**CHARTER TOWNSHIP OF VAN BUREN
PLANNING COMMISSION AGENDA
Wednesday, January 27, 2021 – 7:30 PM
REMOTE MEETING –AGENDA**

RE: Planning Case 19-001: Project Sycamore Data Center – Requested Extension and Amended Final Site Plan Review

**Subject: VBT-19-001; Project Sycamore; 9000 Haggerty Road; AMENDED Site Plan Review #2;
Revised Site Plans Dated October 28, 2020.**

Project Sycamore – 9000 Haggerty Road Engineering and Final Site Plan Review

Figure 2: Amended site plan

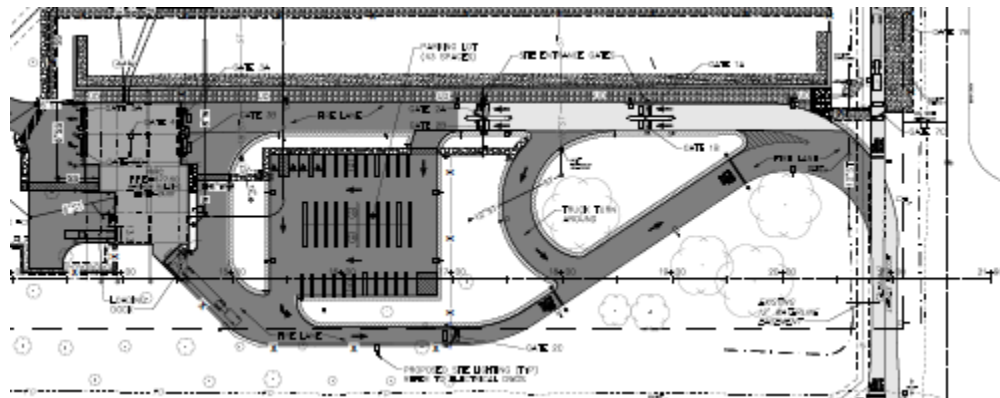
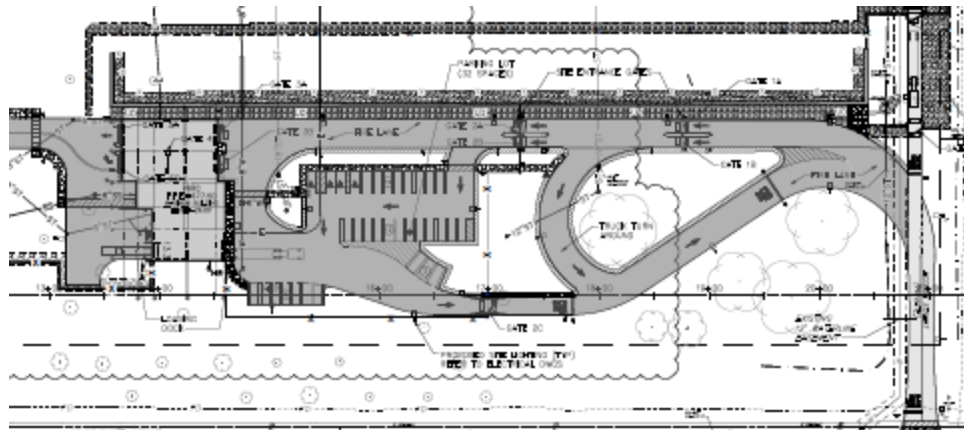
The previously approved plan (shown below – figure 1) had vehicles enter and exit the site off Haggerty and then move in a one-way direction towards the VVRC building for security check. The parking lot on the east side of the VVRC building had limited amount of parking with a one-way circulation pattern creating a loop.

The amended plan proposed (figure 2 above) eliminates the angled truck dock at the northeast corner of the VVRC building, reduces the amount of parking shown and creates a small new area of parking abutting the dock area. The circulation continues to remain in a one-way configuration forming a loop.

The approved plan included a “crossover” pattern proposed off Haggerty Road with stop signs to ensure safe movement of traffic when crossing over. Due to the highly secure nature of the facility, all vehicles are required to check in at the VVRC building with only regular employees being allowed inside the main site. All temporary workers or visitors to the site will be required to park at the VVRC lot and walk across to the main building. The drop-off area for taxis on the loop preceding the VVRC building remains unchanged.

Figure 3: Amended site plan

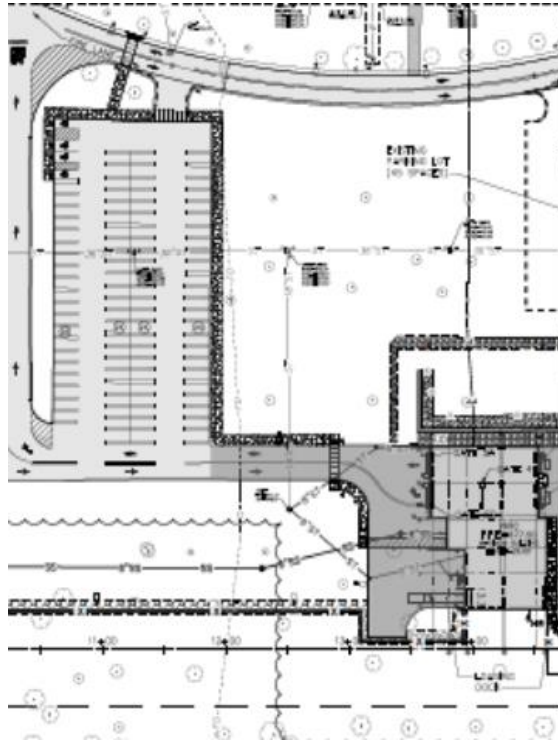
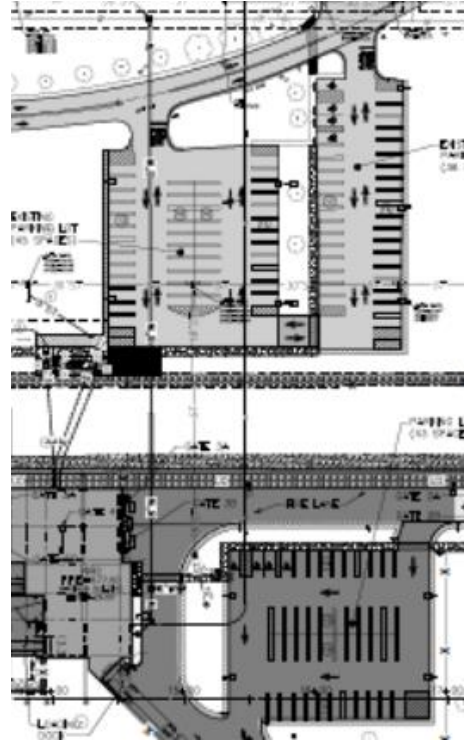
- a. Space Dimensions.** The amended site plan proposes the creation of a new parking lot on the southwest side of the VVRC building (figure 3) and elimination of the previously proposed reconfigured existing parking lot on the northwest side of the VVRC building (figure 4). Sheets C-3003 and C-3005 provide details of the proposed parking areas. All spaces measure 9.5’ x 20’, and are double striped as required. The aisle width is 24’ as required by the Ordinance. The parking area abutting the VVRC building has appropriate pavement marking to show one way movement of vehicles.

- b. Number of Parking Spaces.** The approved site plan included a total of 139 parking spaces, when the ordinance required a total of 252 spaces. The applicant successfully presented to the Planning Commission that based on the restricted use of the site, a total of 58 spaces are sufficient to meet the needs of the site. Under the provisions of section 9.101(J) of the Zoning Ordinance the Planning Commission allowed for the reduction in spaces for a total of 139. The amended plan at this time proposes a total of 130 spaces, which is a further loss of 9 spaces. Per the applicant the restricted use of the site will now require only 54 spaces, leaving a surplus of 76 spaces. The applicant is requesting a deviation from the Planning Commission.

1. Approval of the reduced parking count for the site.
2. Payment into the Township tree fund for frontage landscaping shortfall and missing replacement tree.
3. Clarification of dumpster location near VVRC building on site plan.
4. Clarification regarding screen wall extension on southeast corner of VVRC building.
5. Township Engineer and Wayne County approval of drainage and utility plans.
